Model 80

1932-33

I.F. 460 Kc.

DATA SHEET

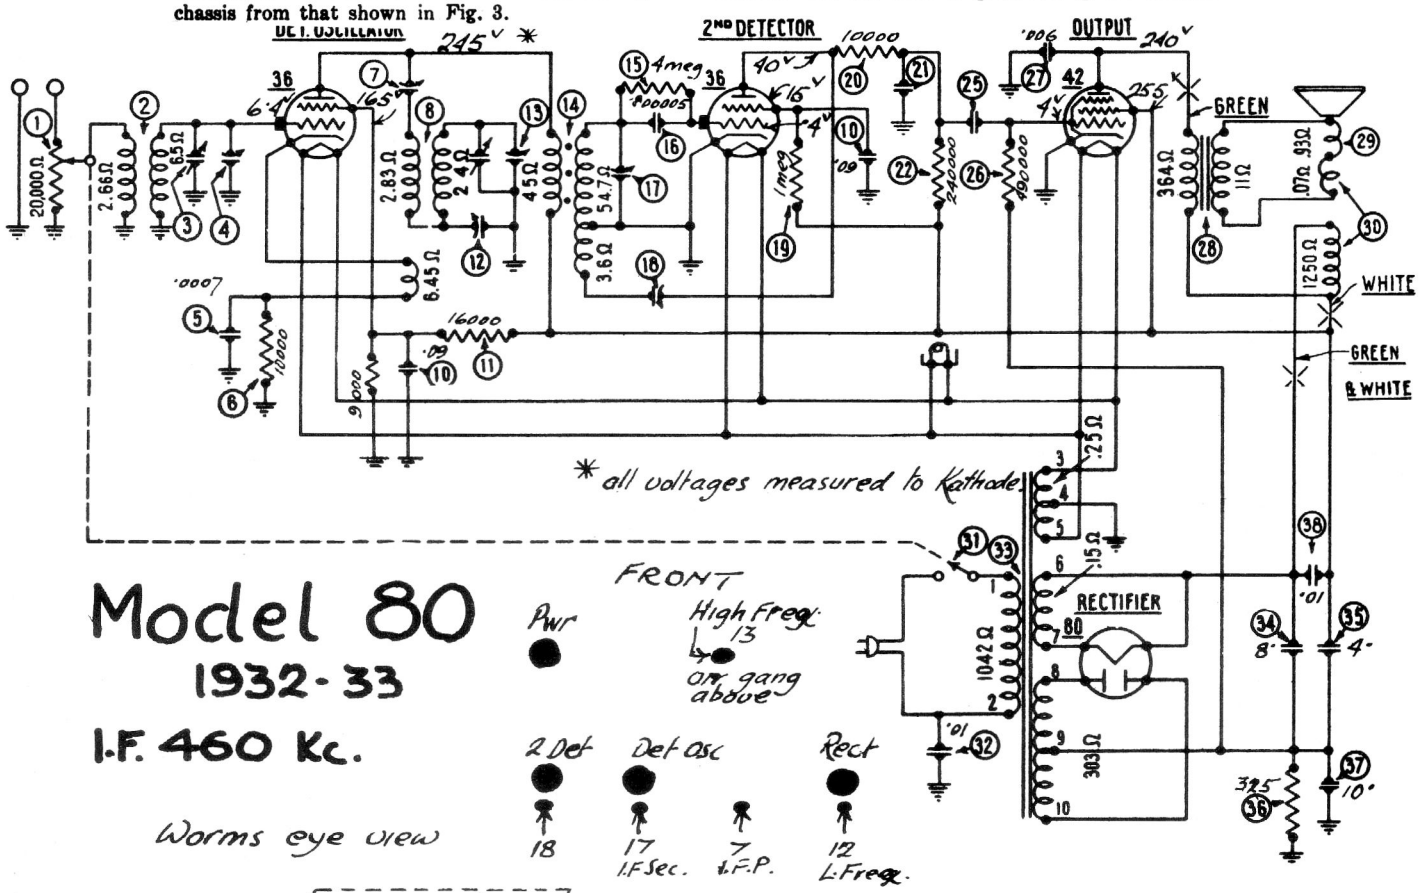
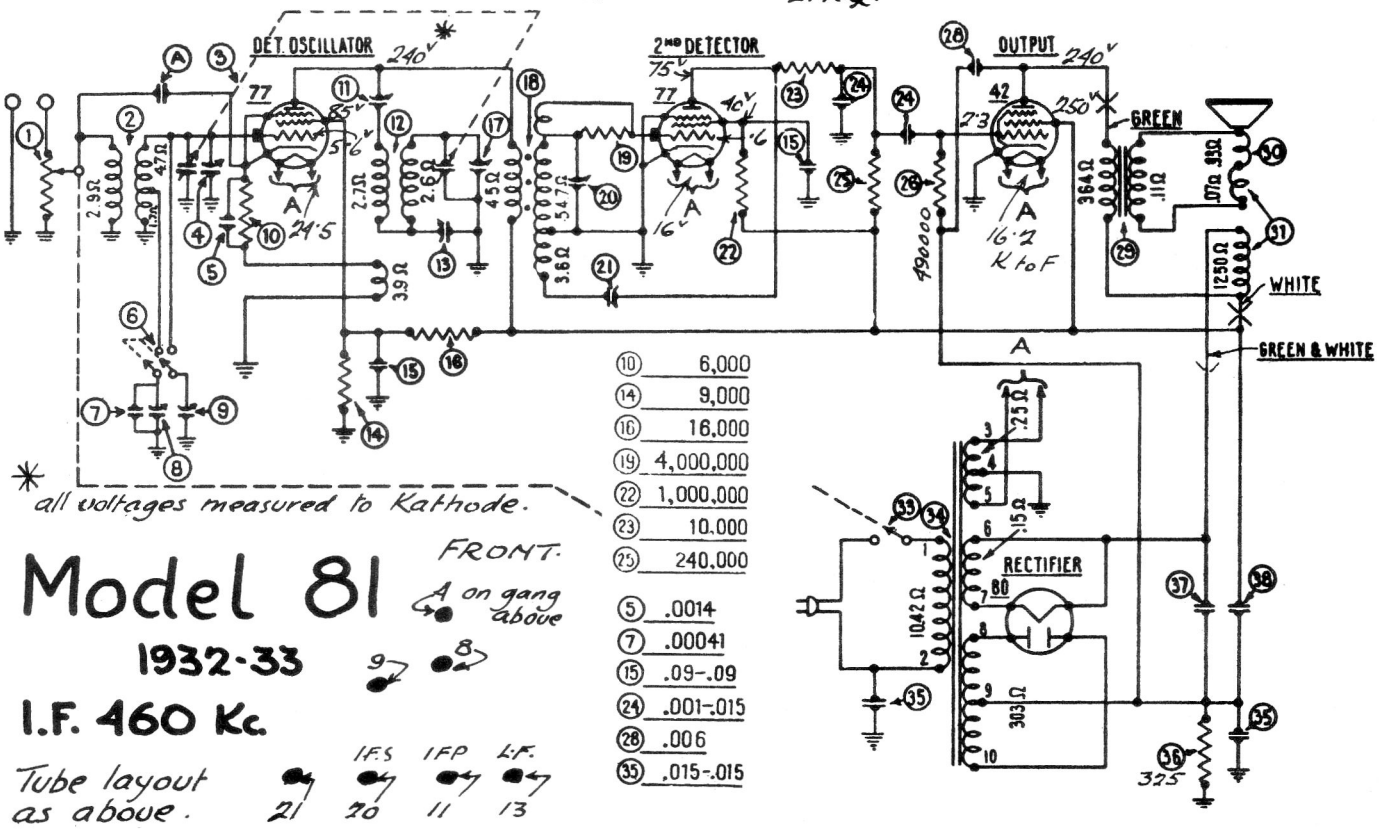
* A number of circuit changes were made on chassis of run No. 5 and above. This run number is rubber stamped in a star on the back of the chassis. Refering to Figs 2 and 3, the condenser (27) connects to the B- end of resistor (36) instead of to ground. The bucking coil - that section of (30) in series with the voice coil - is shorted out. The 10 mfd. dry electrolytic condenser (37) is eliminated, and replaced with a substitute .015 section combined with (32), part 3793R. The .01 mfd. condenser (38) is eliminated. The positions of (19) (26) and (36) are changed in the chassis from that shown in Fig. 3.
